**5.1 NO. 81 (LOT: 117; D/P: 2099) EAST STREET, MOUNT HAWTHORN - PROPOSED ALTERATIONS AND ADDITIONS TO SINGLE HOUSE**

To consider an application for development approval for alterations and additions to a single house at No. 81 East Street, Mount Hawthorn (the subject site).

**Figure 1 – Comparison of shadowing from Family Wall & existing dividing fence**

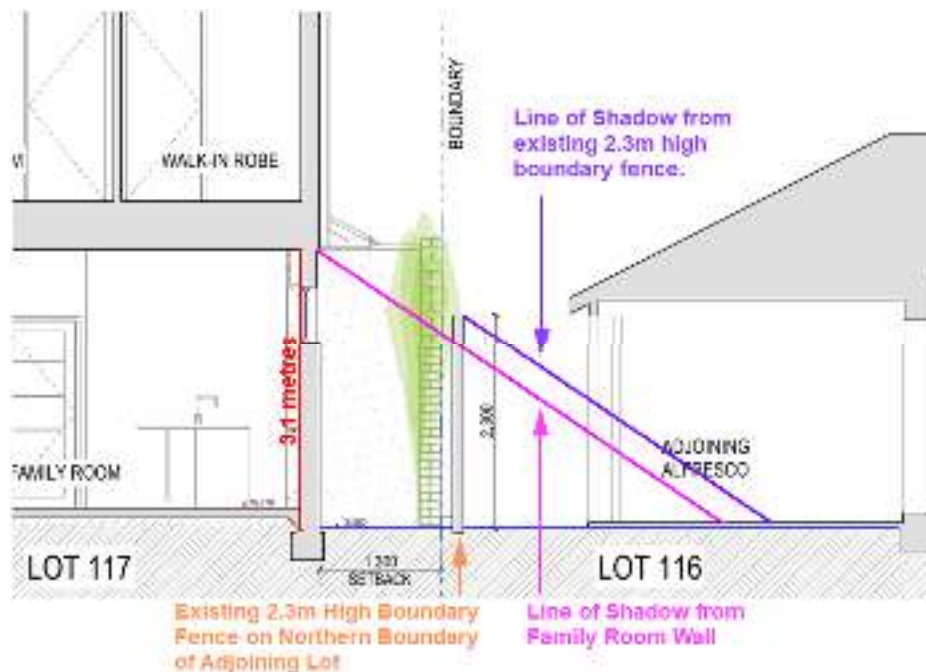
- Impact on Solar Access:** The total amount of overshadowing would comply with the deemed-to-comply standard of the R Codes. Notwithstanding this, the proposed wall to the Family Room that does not meet the lot boundary setback deemed-to-comply standard would not reduce the amount of sunlight provided to the southern adjoining property. This is because the shadow that would be cast by this wall would fall on the existing 2.3 metre high boundary wall. This existing boundary wall itself would cast a greater shadow compared to that from the Family Room wall, as shown below in **Figure 1**. This figure shows the shadow cast on 21 June at winter solstice when shadowing is at its worst, as per the deemed-to-comply standard in the R Codes.

**2 South Elevation**  
1:100

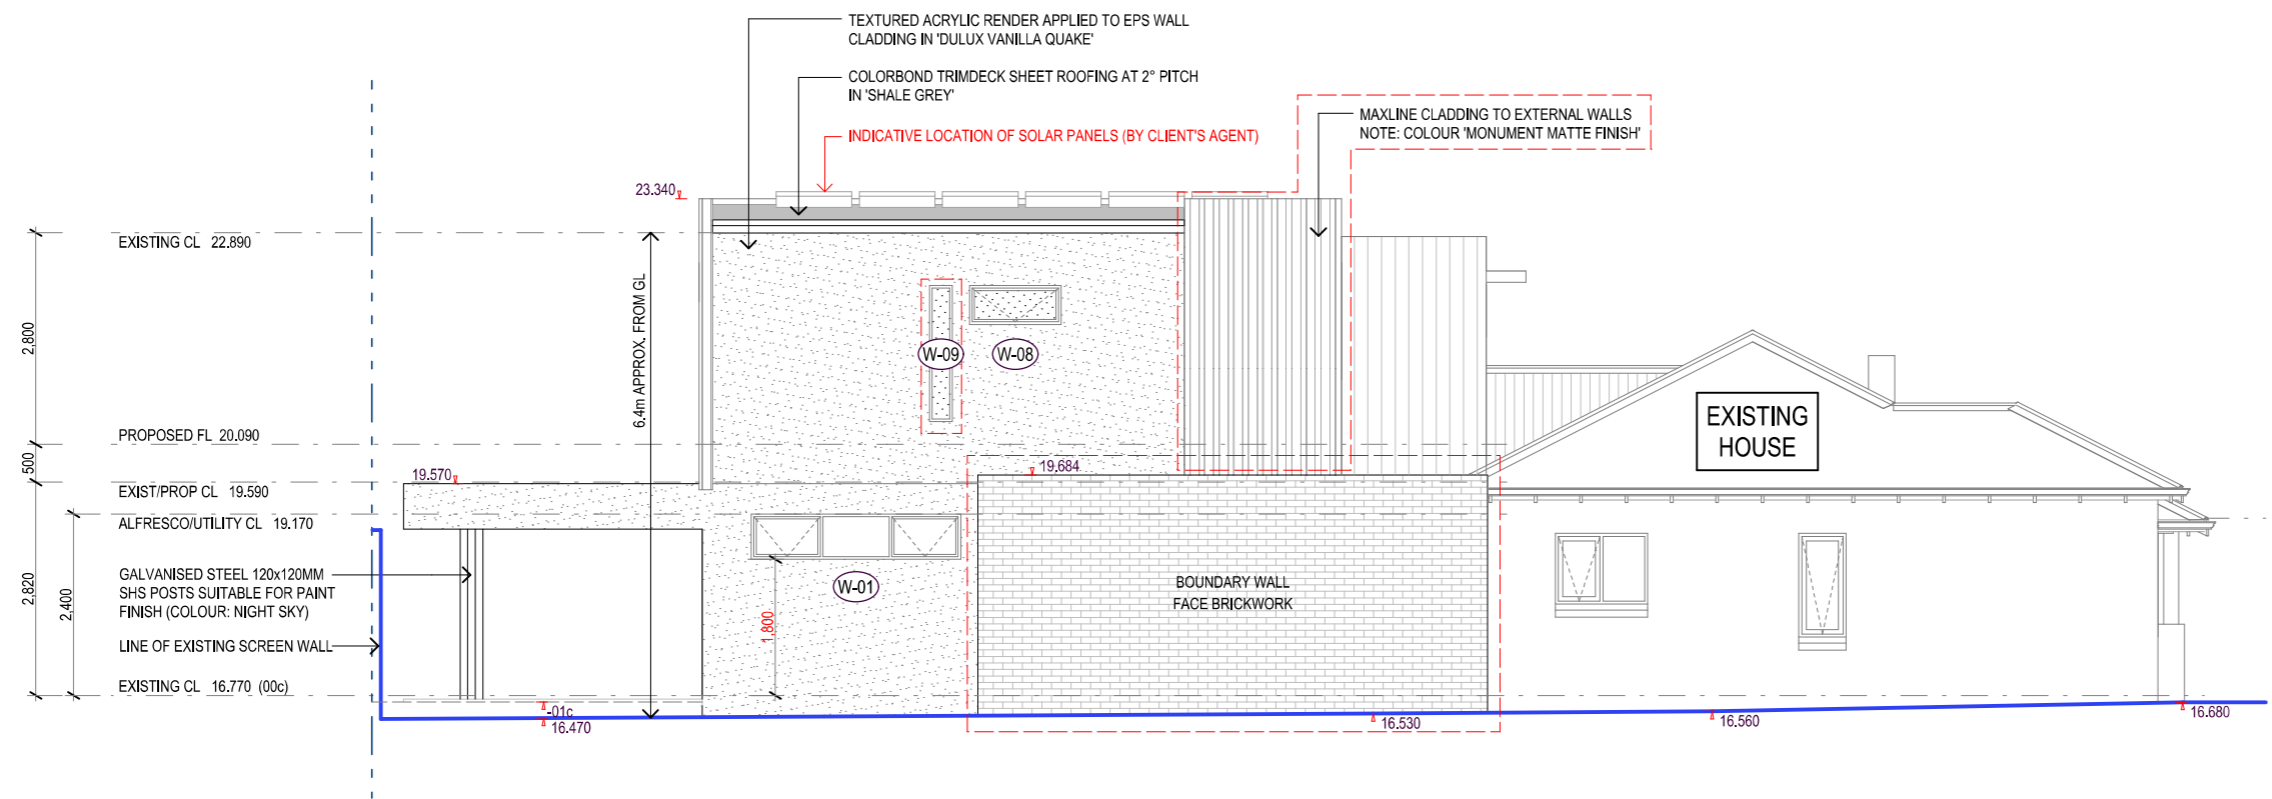
- The south elevation of the rear addition appears quite boxy in form, with a lack of diversity of colour and materiality predominantly employing a painted render finish. Given the high-quality materiality on all other elevations the applicant is encouraged to increase the use of the Maxline or James Hardie Axon cladding products on this façade to break down the scale of the development to the south.

- The southern side setback at ground floor level does not meet deemed to comply standards. The applicant should consider introducing a recess in the ground level facade where the laundry/butler's kitchen is located to articulate this façade.

- The addition of the Maxline cladding on the side elevation is positive but additional areas of cladding are required. The additional setback of the ground floor and upper floor did not sufficiently break up the bulk of the southern elevation.
- The indicative tree locations and the nominated colours for the cladding and render, which includes the 'Monument Matte Finish' for the Maxline cladding are supported.
- Tree species details and full details for finishes and materials are required to be provided.
- The suggestion of adding a recess in the southern elevation near the butler's kitchen has not been addressed.

- The setback of ground floor and upper floor from the southern boundary increased from 1.2 metres to 1.3 metres.
- A portion of Maxline cladding was added the upper floor southern elevation to reduce visual bulk and increase articulation.
- The setback from the northern boundary of the upper floor Main Bed/Home Office wall decreased from 4.7 metres to 4.6 metres.
- The indicative location of deciduous trees was provided along the northern boundary to assist enhancing visual privacy between properties, along the southern boundary to assist in softening the visual bulk of the south-facing wall, and in the front setback area to East Street to improve streetscape canopy.
- Colours for the Maxline cladding and textured acrylic render were nominated. The colour of the Axon cladding was not confirmed but was noted to be a contrasting colour.

- The setback from the southern boundary of the ground floor family wall was further increased from 1.3 metres to 1.4 metres.
- Additional Maxline cladding added to a portion of the upper floor ensuite wall and an additional minor opening was added to the WIR wall.
- The material finish of the boundary wall to the southern boundary was amended from 'Textured Acrylic Render' to 'Face Brickwork'.
- Indicative trees species details for the proposed landscaping were provided with deciduous 'Magnolia Little Gem' trees along the northern boundary to allow northern winter light into the dwelling, fast growing 'Clumping Bamboo' planting along the southern boundary to provide visual screening in the shorter term, and a 'Jacaranda' tree in the front setback to East Street, consistent with existing street trees on East Street.

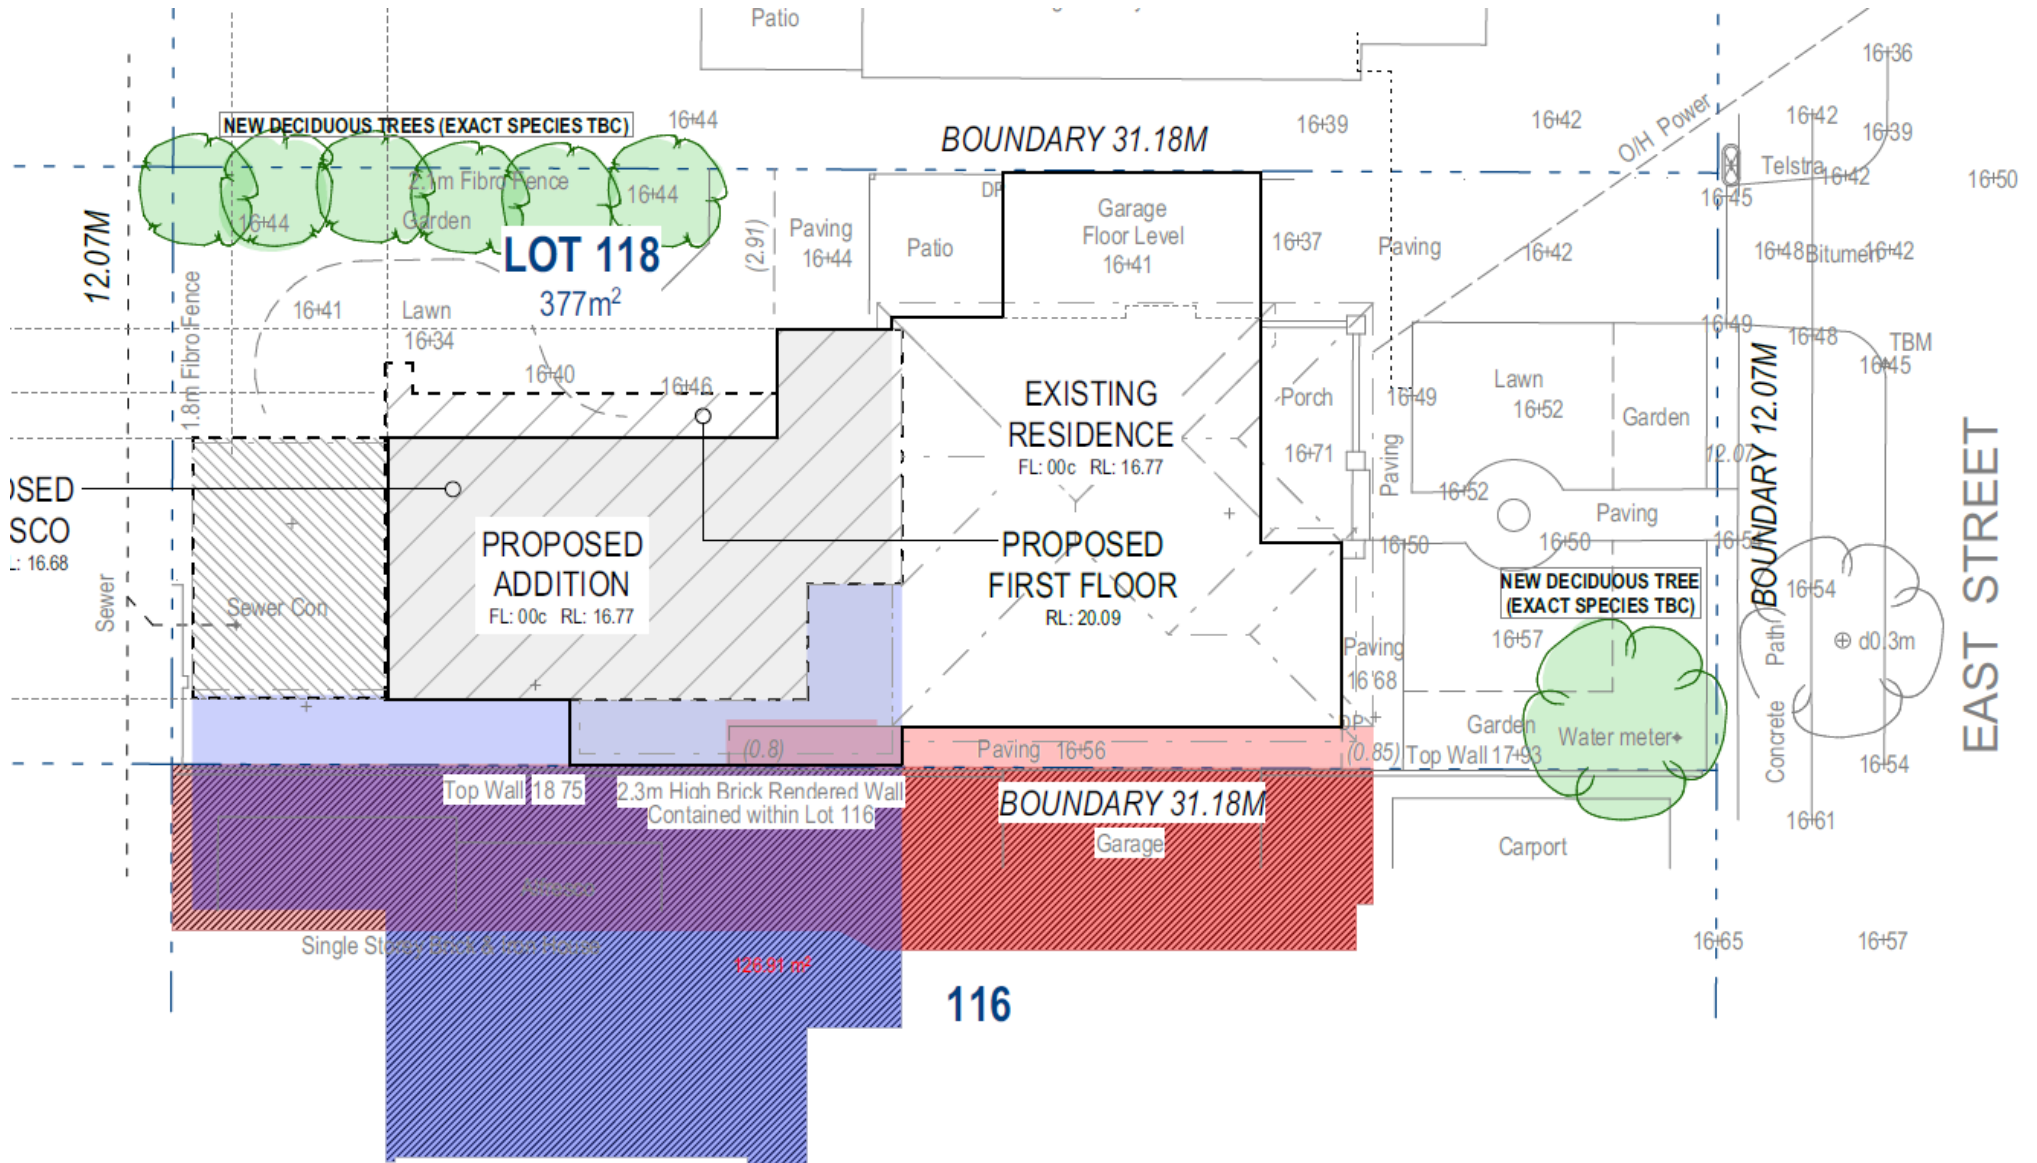
Comments Received in Objection:	Applicant Comment:
<p data-bbox="107 210 376 236"><u>Environmental Design</u></p> <ul data-bbox="107 274 1012 523" style="list-style-type: none"><li data-bbox="107 274 1012 331">• The black colour of the additions are not environmentally sustainable and would require more cooling</li><li data-bbox="107 338 1012 395">• Concerns regarding radiation of heat due to colour and scale of the additions.</li><li data-bbox="107 402 1012 459">• Concerns relating to radiation of heat and reflection due to mass of structure in summer months</li><li data-bbox="107 466 1012 491">• The black box will provide more urban heat than near any other design.</li><li data-bbox="107 497 1012 523">• The development will have a negative thermal performance.</li></ul>	<ul data-bbox="1093 242 2101 545" style="list-style-type: none"><li data-bbox="1093 242 2101 386">- Proposed addition will be subject to 6-star energy efficiency rating, and has been designed to leverage the northern aspect by means of North-facing openings, and minimal opening to the South and West. Metal cladding on framed structure has little thermal mass in comparison to masonry or concrete which will retain, reflect and radiate heat.</li><li data-bbox="1093 392 2101 545">- White cladding would create more glare and reflection onto neighbouring houses. Other local government bodies e.g. Town of Cambridge prohibit light-coloured roof/ cladding for this reason. While, on the surface, white/surfmist seem an ideal choice for thermal performance, its impact on the amenity of neighbouring dwelling is potentially greater.</li></ul>

Site plan/shadow diagram. Orange shading indicates existing overshadowing, predominantly caused by 2.3m high brick rendered wall contained within Lot 116. Proposed overshadowing in blue shows it'll mostly overlap with existing shadow, or cast over the roof of adjoining dwelling on Lot 116.
